DEPARTMENT OF THE ARMY
UNITED STATES ARMY EVALUATION CENTER
2202 ABERDEEN BOULEVARD – SECOND FLOOR
ABERDEEN PROVING GROUND, MD 21005-5001

13 February 2012

SUBJECT: Safety Confirmation for the Forward Operating Renewable Generator (FORGE) in Support of Rapid Equipping and Associated Continental United States (CONUS) Pre-deployment Training

Figure 1. FORGE System.

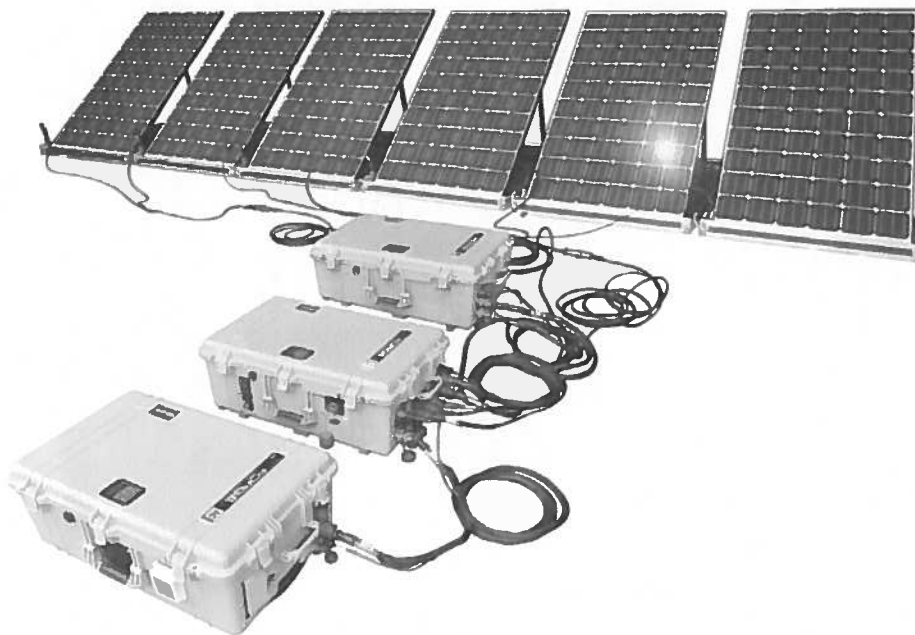
d. During setup of the solar panels, the latches on the solar panel cases were difficult to operate and were identified as a potential pinch point. The hinges and latches on the solar panels themselves were also identified as potential pinch points. Additionally, the corners of the solar panels are sharp. The possibility of Soldier injury during setup due to numerous pinch points and sharp corners is assessed a Negligible-Occasional hazard (RAC 4-C, LOW Risk), provided Soldiers wear heavy duty work gloves.
